**TOWN OF NEWBURGH  
PLANNING BOARD  
TECHNICAL REVIEW COMMENTS**

**PROJECT: POND VIEW 2 LOT SUBDIVISION**  
**PROJECT NO.: 14-19**  
**PROJECT LOCATION: SECTION 10, BLOCK 1, LOT 50**  
**PROJECT REPRESENTATIVE: HUDSON LAND DESIGN**  
**REVIEW DATE: 13 NOVEMBER 2014**  
**MEETING DATE: 20 NOVEMBER 2014**

Re: Pond View Minor 2 Lot Subdivision  
921-965 State Route 32  
Tax ID: 10-1-50 (±10.21 acre)  
T. of Newburgh Project 2014-19

**MHE 10/18/14 Review Letter**

**DRIVEWAY SECTION DETAIL**  
NOT TO SCALE

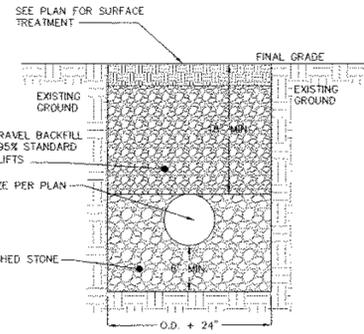
3. Notes have been added to the detail specifying where geotextile separation shall be used. In addition, biaxial geogrid is specified at the wetland crossing.

**LOT 2 DRIVEWAY CROSS SECTIONS AT WETLAND CROSSING**  
SCALE: 1"=10'

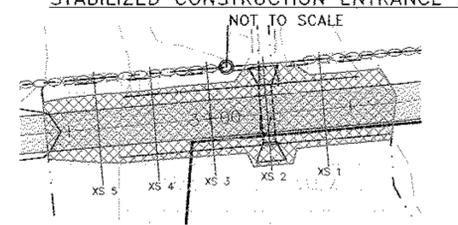
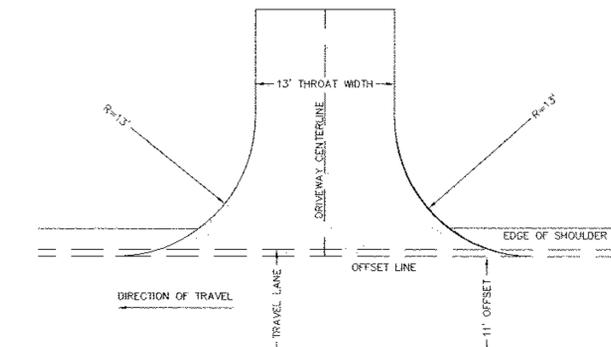
1. The topographic survey has been updated via ground survey by Daniel Yanosh, L.S. within the development areas including the area of the wetland crossing and outlet channel. Soil test locations, water edge and some offsite wells and septic areas were also surveyed which have been updated on the map. The Lot 2 driveway has been moved farther away from the northerly property line at the wetland crossing to avoid impacts to the existing stone wall and adjacent property as a result of grading activities. A pre and post-construction watershed study has been completed for the proposed culvert crossing. The proposed culvert has been modeled in HydroCAD and the results show that post-construction flows are slightly less than pre-conditions while maintaining a similar water elevation within the wetland. The HydroCAD model and a watershed map is included in this submission for review. Five cross sections have also been provided along the Lot 2 driveway at the wetland crossing on Sheet 2 of the plan set.

6. A "Certificate of Occupancy" note has been added to Sheet 1 of the plan set requiring a certified as-built prior to receipt of c.o..
7. The culvert has been revised to a 48" culvert buried 17" below the invert of the outlet channel. The 30% note has been removed.

**LOT 1 DRIVEWAY PROFILE**  
SCALE: 1"=5'V  
1"=50'H

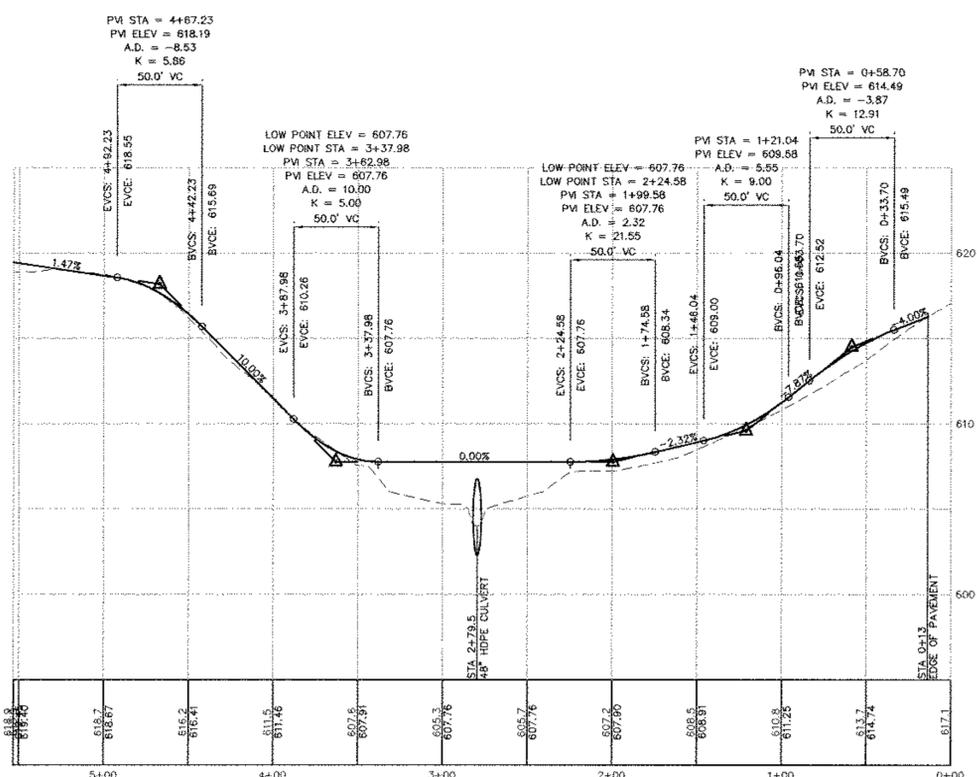
2. The Applicant wishes to keep the driveways separate. The Lot 1 driveway has been moved to the south to provide adequate separation between the driveways in accordance with Figure 5A-3 of the NYSDOT Highway Design Manual (HDM) Chapter 5A draft regulations dated April 16, 2014. The HDM requires a minimum of 30 feet separation between driveways where the flare meets the edge of pavement. The plan shows 40 feet separation. Although the HDM regulations are in draft form and not effective yet, it is likely that they will be soon. Therefore, for the board's consideration the Applicant respectfully requests that the driveways remain separate. This is also subject to review by NYSDOT.

**1,000 GAL. SEPTIC TANK/PUMP CHAMBER DETAIL**  
NOT TO SCALE

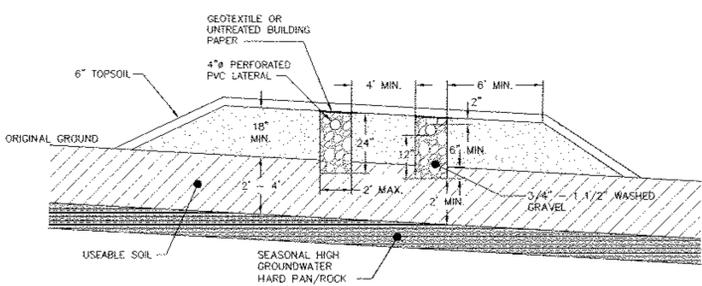
4. Dosing calculations have been completed for the pump system on Lot 1, and the detail has been updated with the information. The calculations are included in this submission for review.

5. The pump chamber provides 730 gallons of storage capacity above the high level alarm which is nearly two days of storage. Therefore, a backup generator is not required and the notes have been removed from the plans.
